## COMMISSION IMPLEMENTING REGULATION (EU) 2018/502

**amending Implementing Regulation (EU) 2016/799 laying down the requirements for the construction, testing, installation, operation and repair of tachographs and their components**

Figure 1

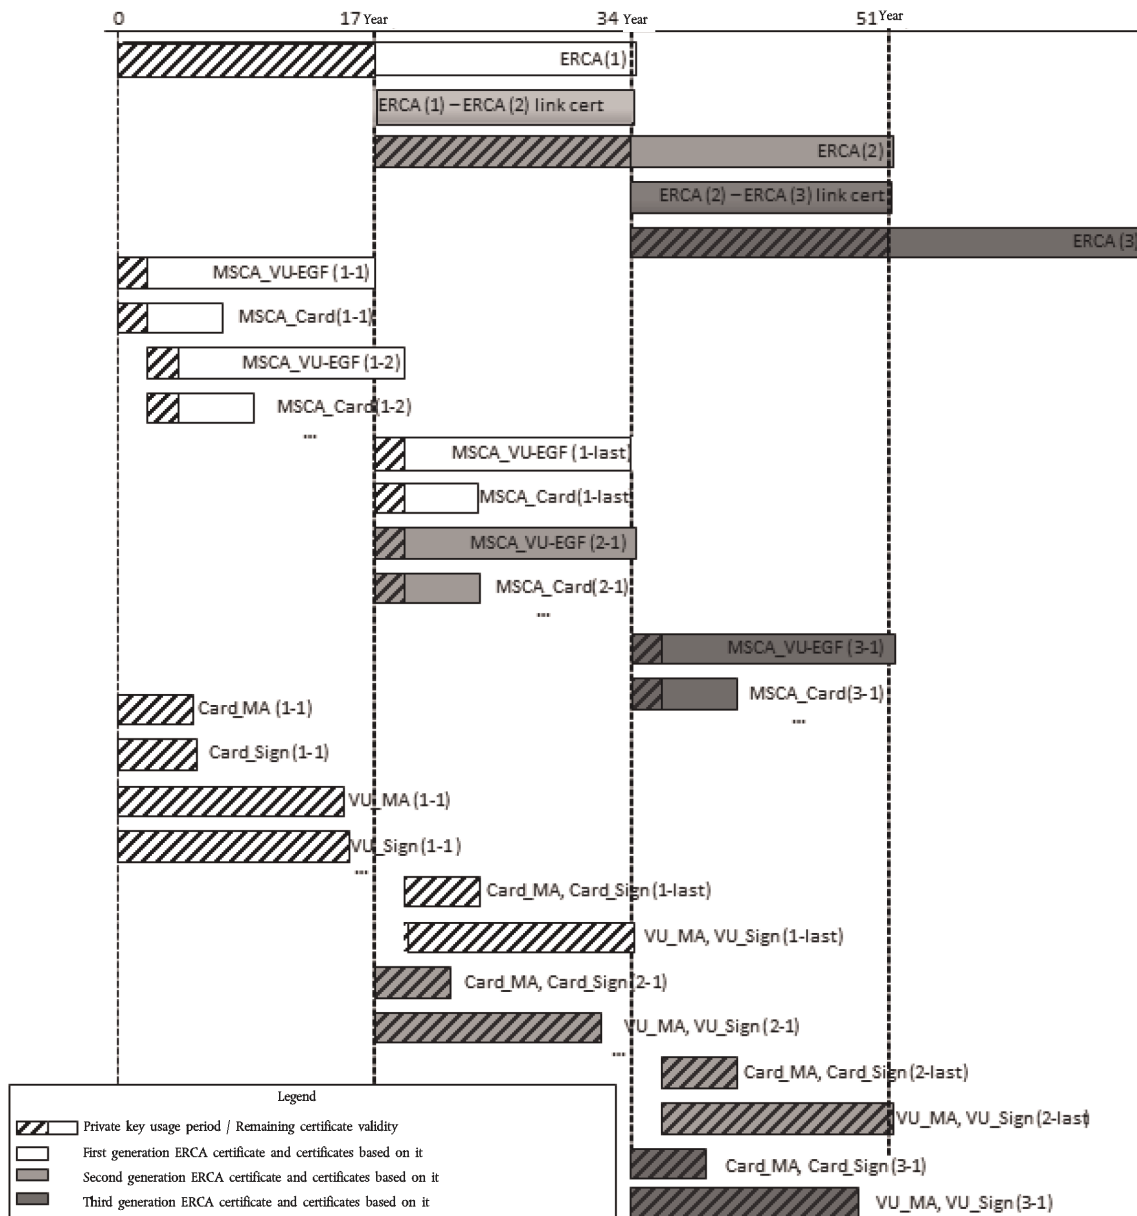
(i) Figure 1 is replaced by the following:

**Issuance and usage of different generations of ERCA root certificates, ERCA link certificates, MSCA certificates and equipment certificates**

Figure 6

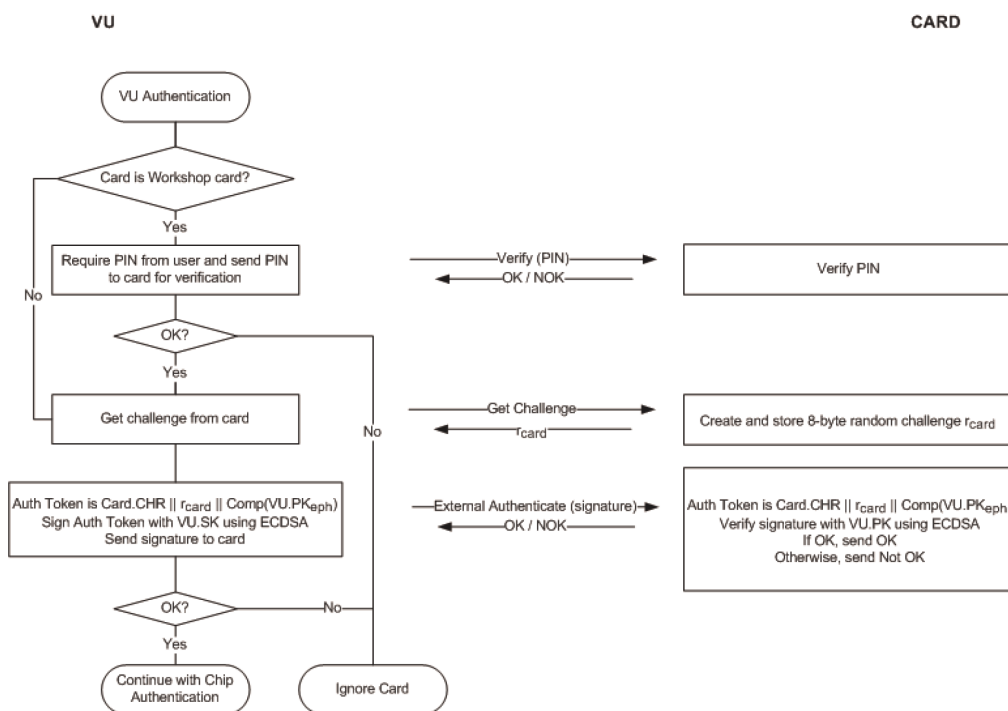
(ii) in paragraph CSM\_171, Figure 6 is replaced by the following:

### VU Authentication protocol

Figure 13

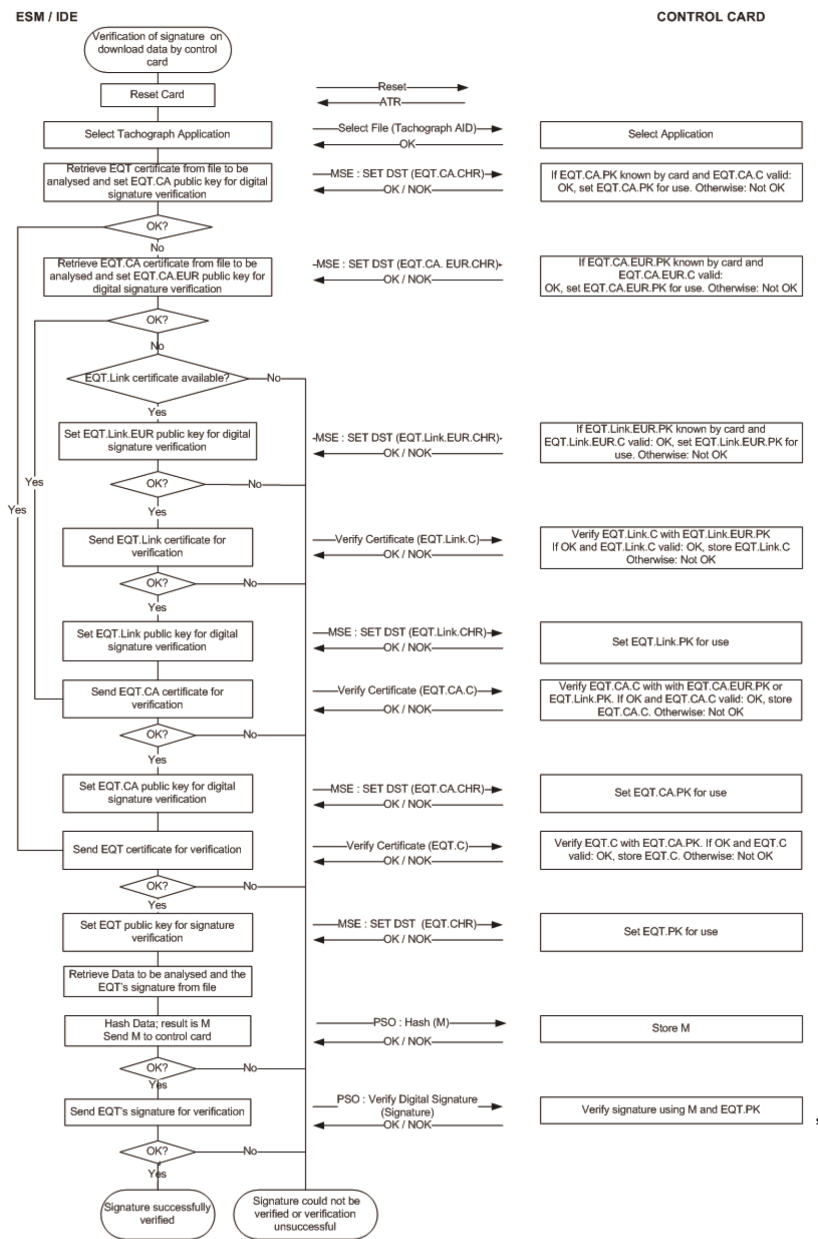
- The CHA of the EQT.Link certificate shall indicate the ERCA.’;
- (ii) Figure 13 is replaced by the following:

Protocol for verification of the signature over a downloaded data file
